**BEAMREACH NETWORKS, INC.
BELL SOUTH CORPORATION
VERIZON WIRELESS, INC.
WORLD COM, INC.**

*Re: Establishment of Rules and Policies for the Satellite
Digital Audio Radio Service in the 2310-2360 MHz Band;
IB Docket No. 95-91*

Response to XM Radio's Supplement to August 29, 2001 White Paper¹

Figure 7

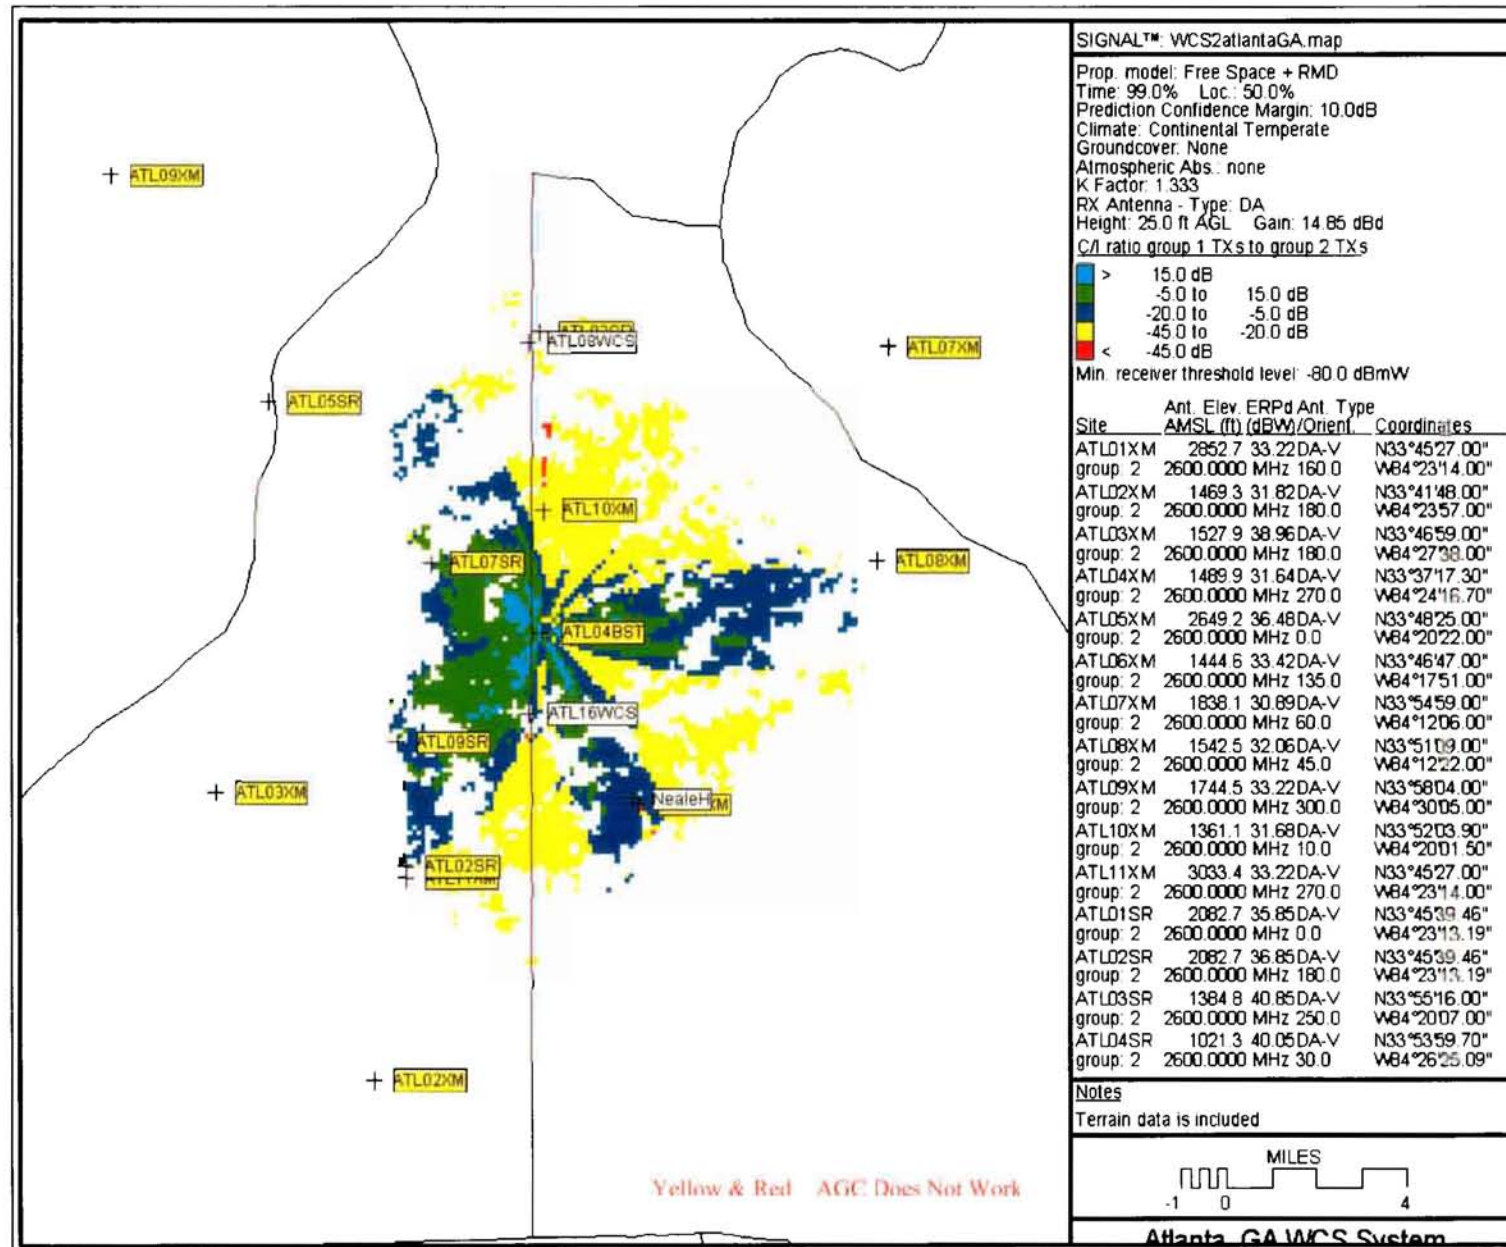
In Figure 7 all fourteen SDARS transmitters are turned on. These SDARS EIRP levels are the levels stated in the XM and Sirius licensees' STA applications. This simulation again looks at the RF coverage area of WCS base station ATL04BST. The WCS CPE in the WCS cell coverage area is equipped with RF front-end AGC. The WCS cell coverage at these SDARS EIRPs is shown by the colors blue, green and bluish green. These colors represent receive levels with a power gap of 20 dB or less.

Because of the inability of the AGC to mitigate the interference, the WCS cell radius has been severely reduced with *a loss in area covered of 44%*.

Figure 8
RF Coverage from WCS Base Station at 2W

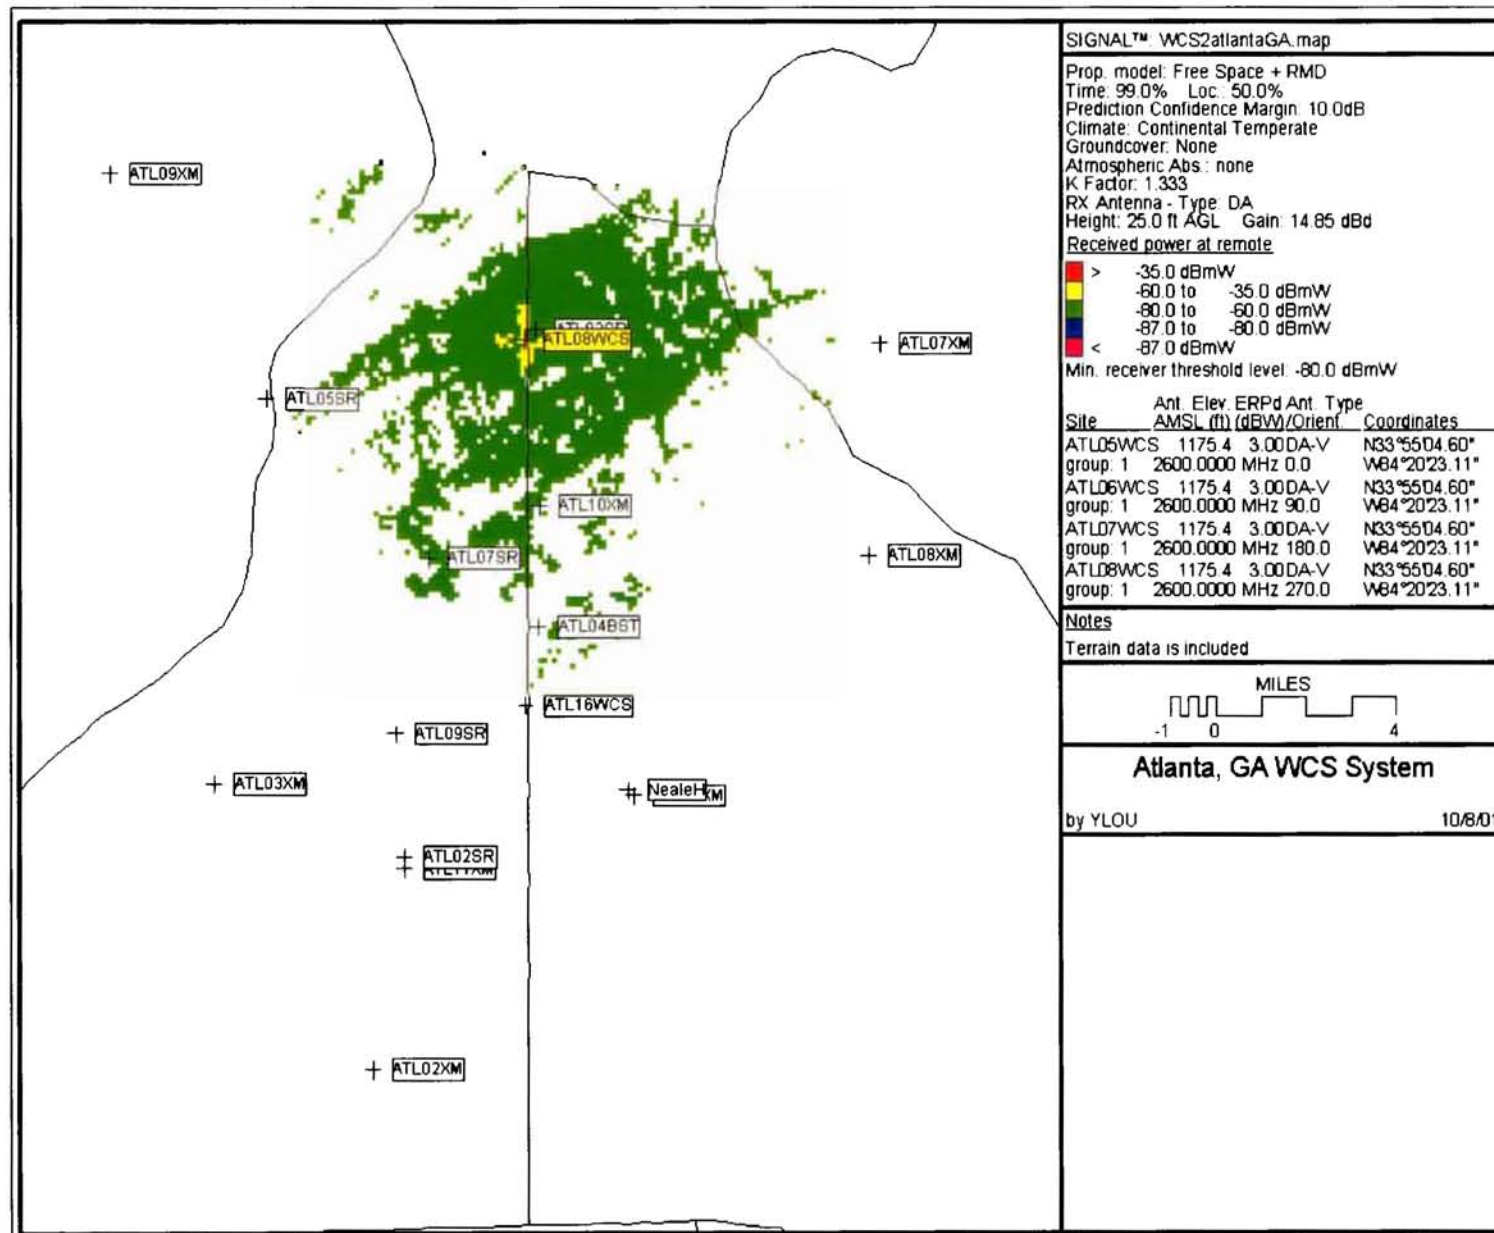
Figure 8 shows the RF coverage area of WCS base station ATL08WCS that is located 8 miles from a non-transmitting SDARS site collocated with WCS base station ATL16WCS. The usable RF coverage includes the areas shown by the colors green and yellow. RF coverage varies from 3 to 6 miles.

Figure 9
SDARS (at 40KW) Interference to WCS System

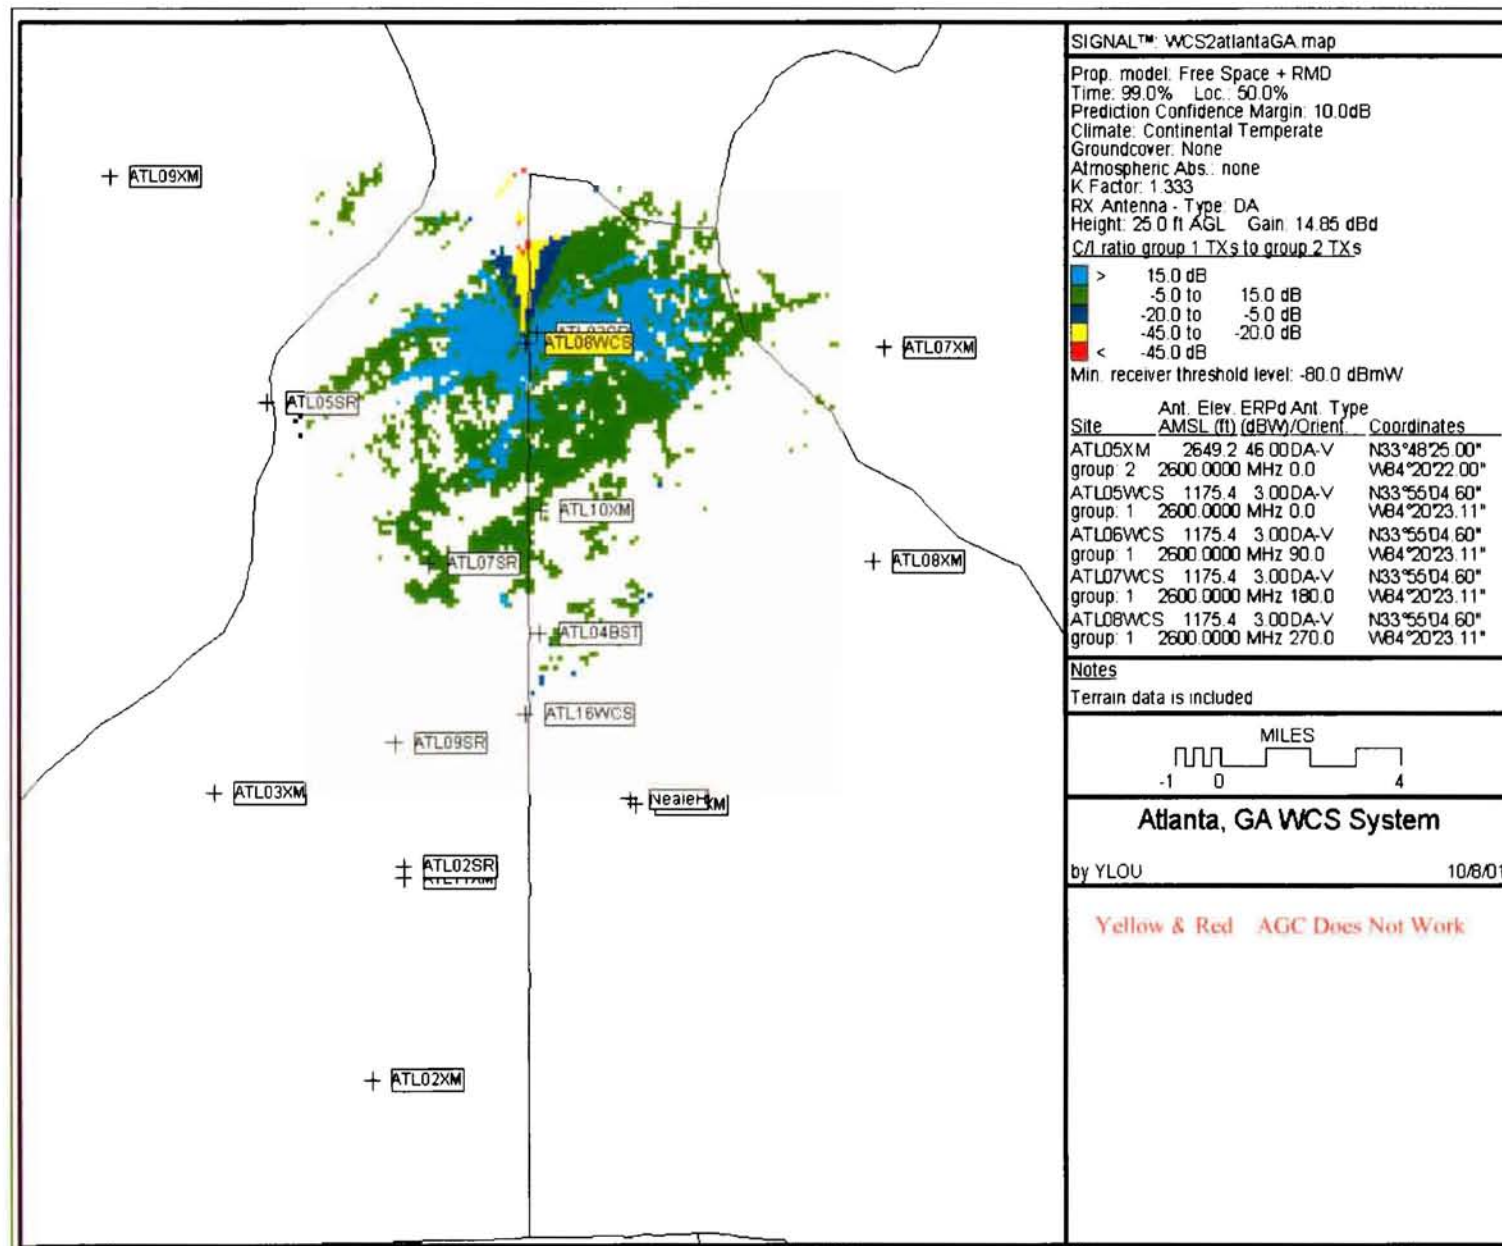
In Figure 9 the SDARS transmitter collocated with WCS base station ATL16WCS is turned on with an EIRP of 40 kW. This simulation again looks at the RF coverage area of WCS base station ATL08WCS. The WCS CPE in the WCS cell coverage area is equipped with RF front-end AGC. The new WCS cell coverage is shown by the colors blue, green and bluish green. These colors represent receive levels with a power gap of 20 dB or less.

Because of the inability of the AGC to mitigate the interference, the WCS cell radius has been reduced to 0 to 6 miles with *a loss in area covered of 1.2%*.

Comparing the areas in Figures 4 and 9 where AGC does not work show that as the WCS cell is moved farther away from the SDARS repeater, the area where AGC does not work is reduced.

Figure 10
SDARS Repeater at 7.3KW (Original Design) Interference to WCS System

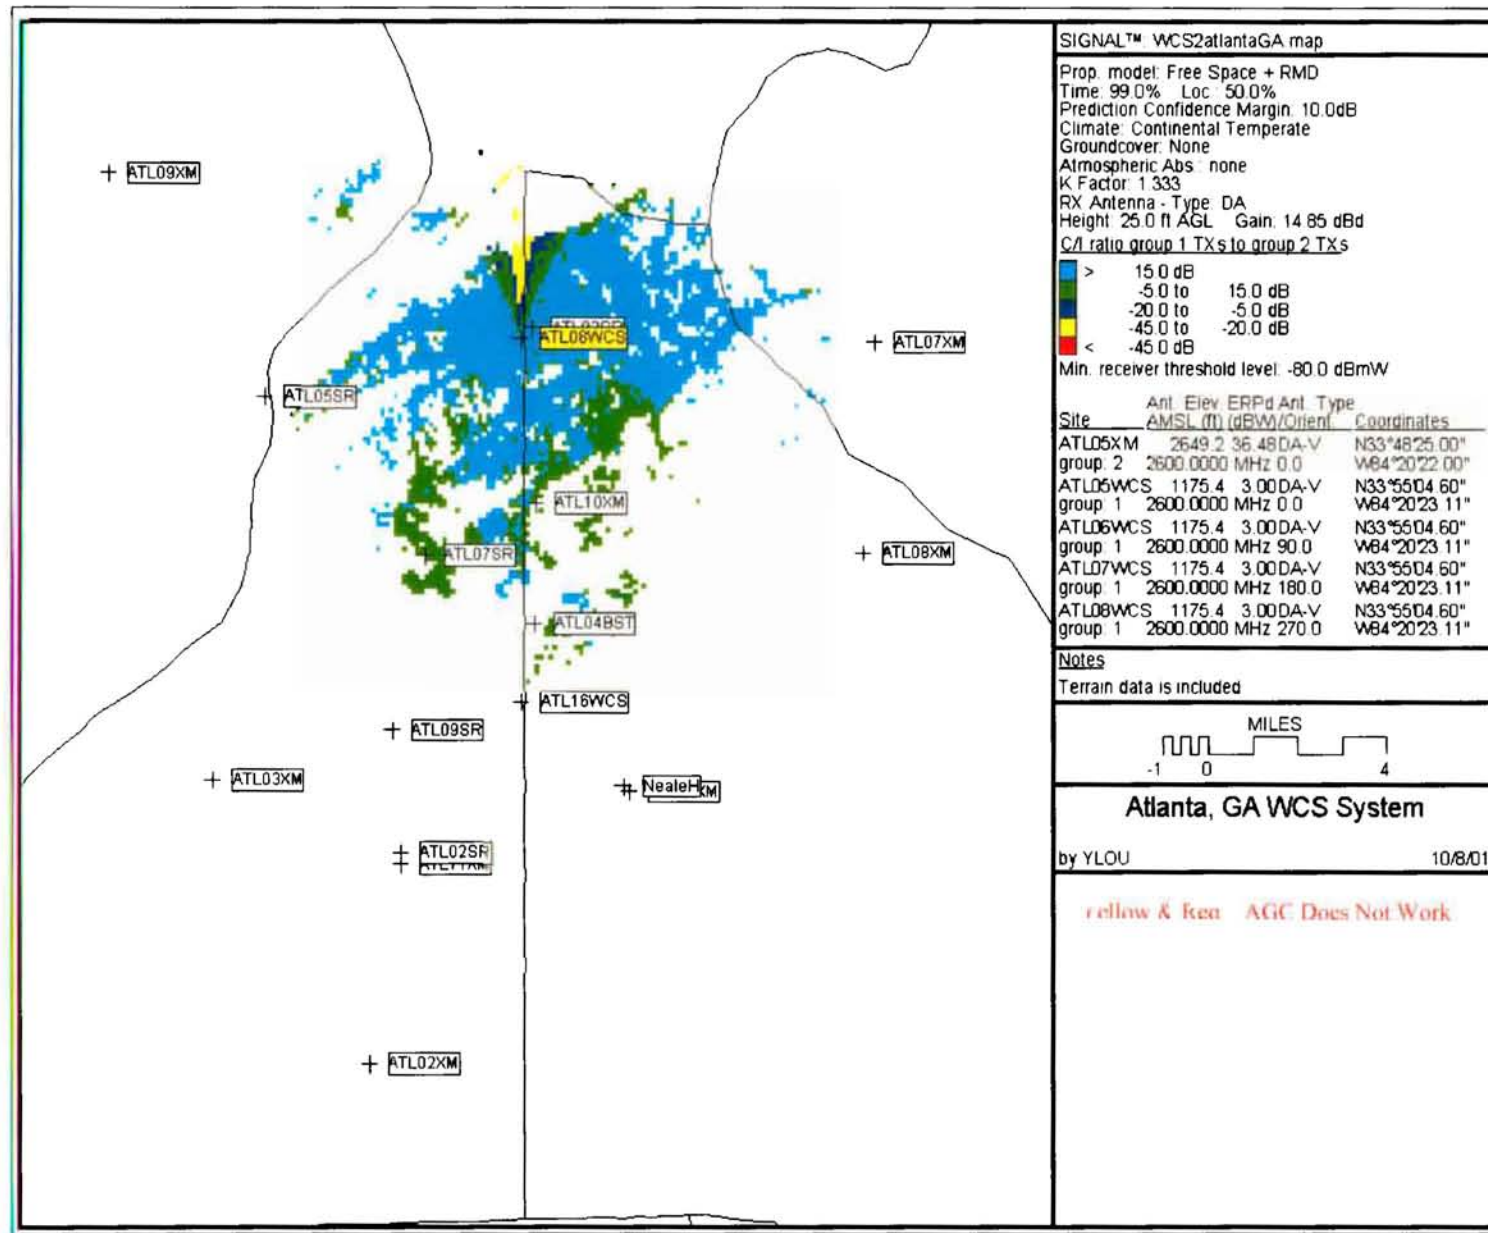
In Figure 10 the SDARS transmitter collocated with WCS base station ATL16WCS is turned on with an EIRP of 7.3 kW. This SDARS EIRP is the level stated in the SDARS STA application. This simulation again looks at the RF coverage area of WCS base station ATL08WCS. The WCS CPE in the WCS cell coverage area is equipped with RF front-end AGC. The WCS cell coverage at this SDARS EIRP is shown by the colors blue, green and bluish green. These colors represent receive levels with a power gap of 20 dB or less. The area colored by yellow is the area where AGC does not work for intermodulation interference. Because of the inability of the AGC to mitigate the interference, the WCS cell radius has been reduced to 0.8 to 6 miles with a *loss in area covered of 1.2%*.

Figure 11
SDARS Repeater at 2KW Interference to WCS System

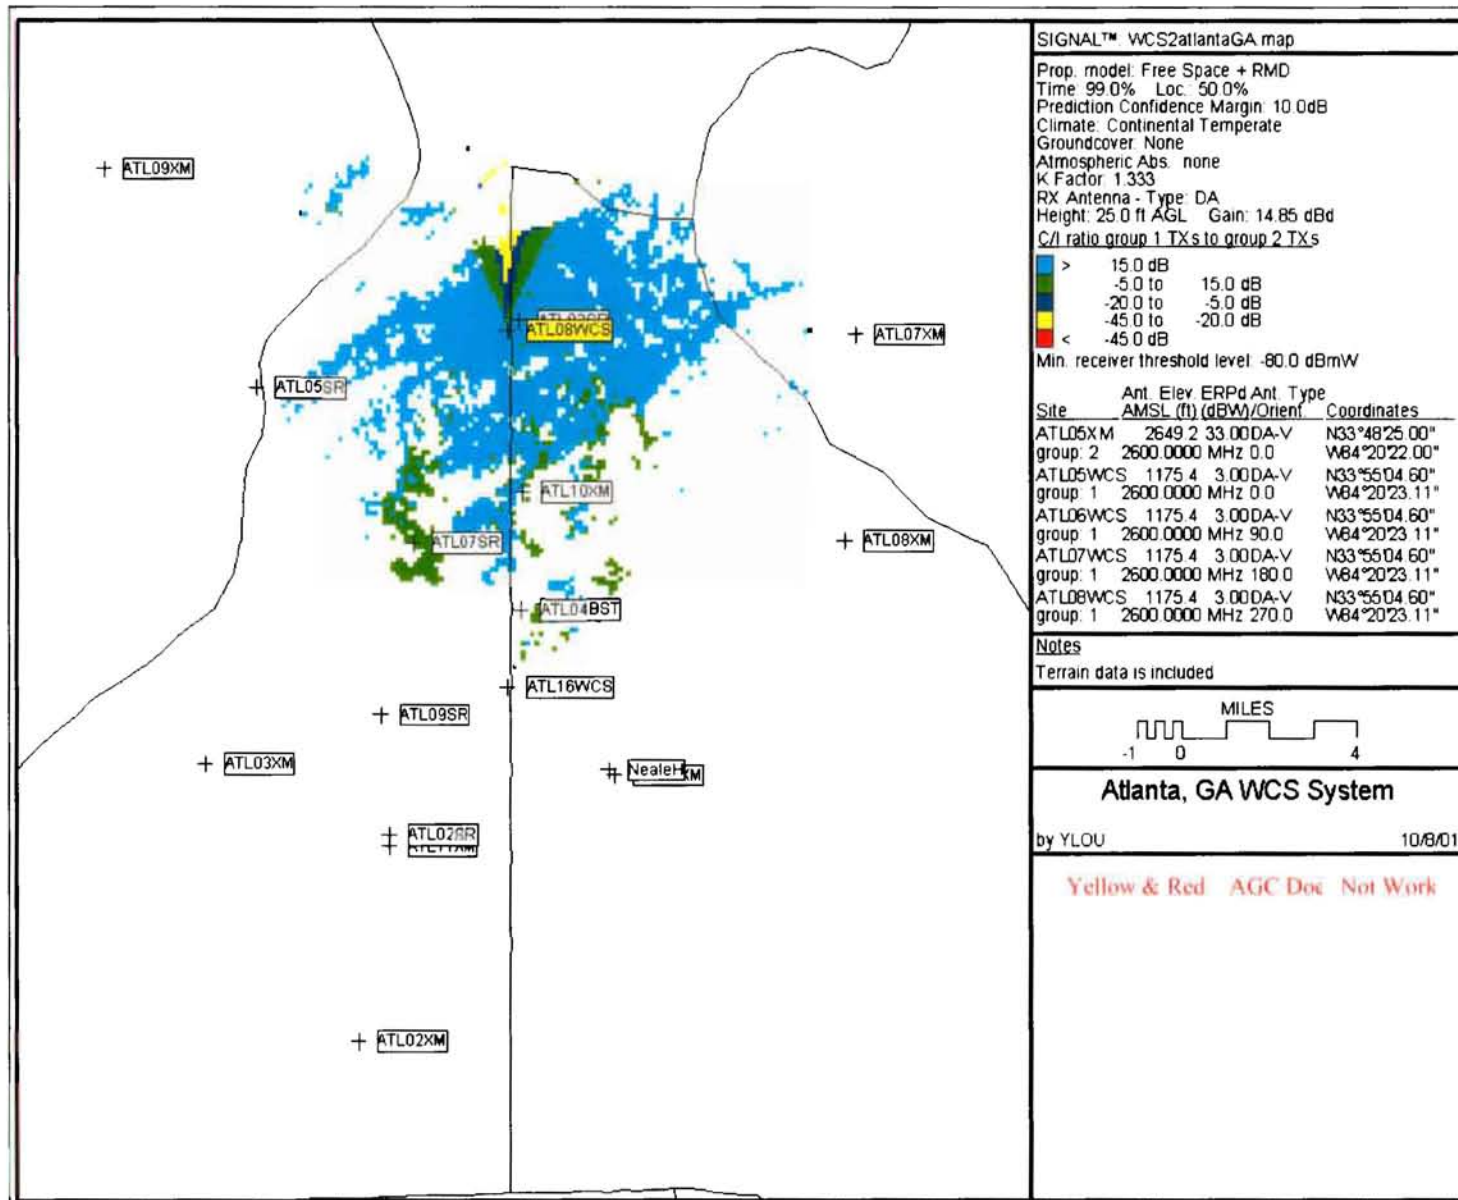
In Figure 11 the SDARS transmitter collocated with WCS base station ATL16WCS is turned on with an EIRP of 2 kW. This simulation again looks at the RF coverage area of WCS base station ATL08WCS. The WCS CPE in the WCS cell coverage area is equipped with RF front-end AGC. The WCS cell coverage at this SDARS EIRP is shown by the colors blue, green and bluish green. These colors represent receive levels with a power gap of 20 dB or less. The area colored by yellow is the area where AGC does not work for intermodulation interference. Because of the inability of the AGC to mitigate the interference, the WCS cell radius has been reduced to 1.2 to 6 miles with a *loss in area covered of 1.2%*.
